| Office Action Summary | Application No. 10/723,304 | Applicant(s) NEUBAUER ET AL. | |

DETAILED ACTION

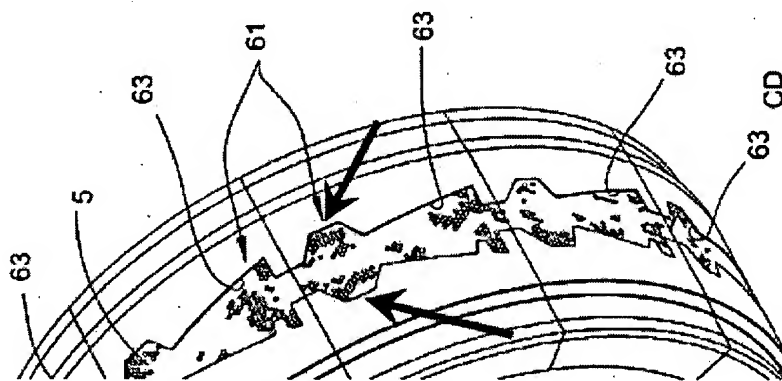
As to claim 2, 6, 25, 26, 37 the applicant claims a set of rear and middle openings, but in the drawings the openings 26 and 30 appear to be the same openings.
